**CITY OF CARPINTERIA
ARCHITECTURAL REVIEW BOARD
Meeting of April 16, 2015**

**COMMUNITY DEVELOPMENT DEPARTMENT
PROJECT REVIEW**

Project: 15-1760-CUP/CDP **Planner:** Steve Goggia
Address: East end of Carpinteria Avenue
Applicant: Matt Roberts, Director of Parks and Recreation

Project Review: Conceptual
 Preliminary
 Final

Rincon Trail

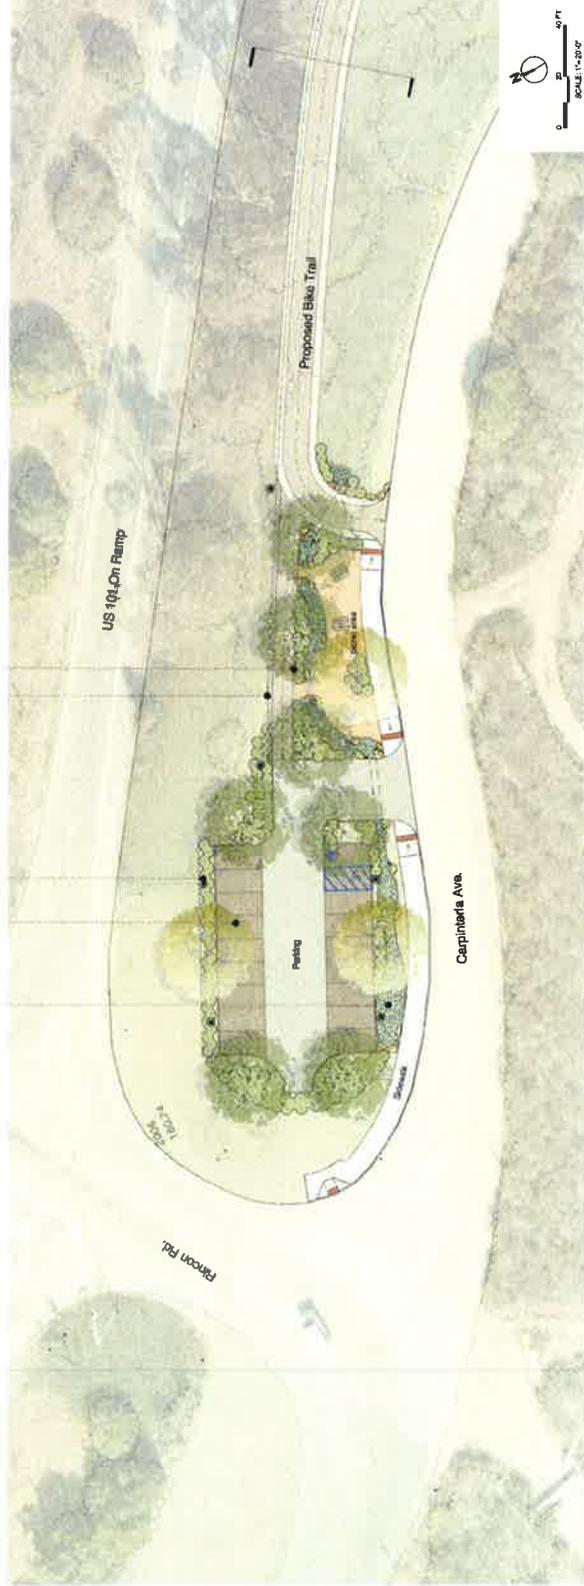
The Rincon Trail, part of the statewide California Coastal Trail, will provide an important bicycle and pedestrian link from the east end of the City to Rincon Beach Park. The trailhead improvements include permeable paving for the parking spaces and neutral concrete or decomposed granite for the parking lot driveway, rest area and trail surface. Proposed lighting, fencing and the water station are shown on the plans and reflect quality design. The picnic tables would be made of recycled plastic. Staff notes that the proposal should incorporate bicycle parking racks within the rest area.

New landscaping around the perimeter of the parking lot and within the rest area includes only native species. Final engineering design plans may include a depressed parking area and/or low berms beneath the perimeter planting areas to help shield the parking area from view pursuant to the policies above.

Proposed lighting includes six full cutoff solar powered LED pole fixtures with a maximum height of 15 feet, with a dimming capability.
